Access Compliance Report

Public Rights-of-Way

(Curb Ramps)

Intersection ID: 20858	Main Street: PARK_RD	Cross Street: SUNVIEW DR	Location: SW
ADA ID: 1EDD14A1BC16	Ramp Type: PerpDiag	Initial Pass/Fail: Fail	Overall Compliance: No
		Severity Score: 50

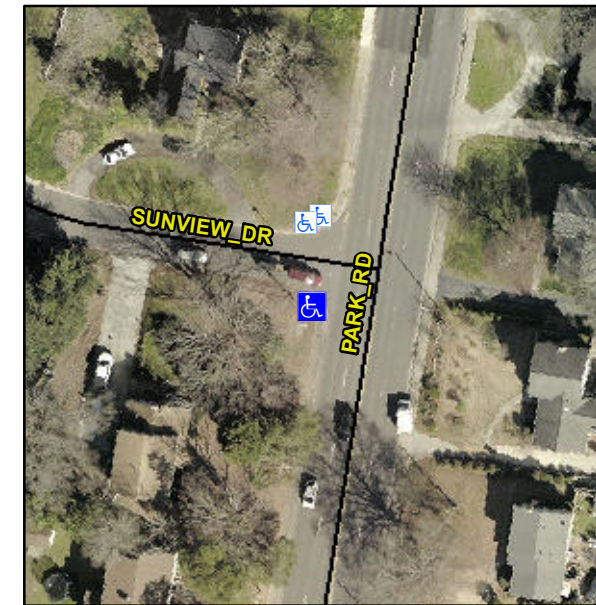
Not Found, R304.2.2, R304.5.3

Compliance	Description	Data	Compliance	Description	Data
N/A	Ramp Length (in)	58.0	No	Ramp Slope (%)	12.9
Yes	Ramp Width (in)	48.0	No	Ramp XSlope (%)	15.6
N/A	Flare Type LT	N/A	N/A	Flare Type RT	N/A
N/A	Flare Slope LT (%)	N/A	N/A	Flare Slope RT (%)	N/A
N/A	Flare Traversable LT?	N/A	N/A	Flare Traversable RT?	N/A
N/A	Landing Length (in)	N/A	N/A	DWS Provided?	N/A
N/A	Landing Width (in)	N/A	N/A	DWS Contrast?	N/A
N/A	Landing Slope (%)	N/A	N/A	DWS Length (in)	N/A
N/A	Landing X Slope (%)	N/A	N/A	DWS Full Width?	N/A
N/A	Landing Curb? (Y/N)	N/A	N/A	DWS Offset (in)	N/A
N/A	Shared Landing?	N/A			
N/A	Gutter Ponding?	N/A	N/A	Gutter Slope (%)	N/A
N/A	Gutter Lip Ht (in)	N/A	N/A	Gutter X Slope (%)	N/A
N/A	Painted X Walk1?	No	N/A	Painted X Walk2?	No
	X Walk 1 Direction	To SE		X Walk 2 Direction	To NE
N/A	X Walk 1 Width (in)	N/A	N/A	X Walk 2 Width (in)	N/A
	X Walk 1 Slope (%)	13.4		X Walk 2 Slope (%)	3.5
	X Walk 1 X Slope (%)	2.3		X Walk 2 X Slope (%)	11.0

Remove & Replace Curb Ramp With Two New Directional Ramps or Equivalent.
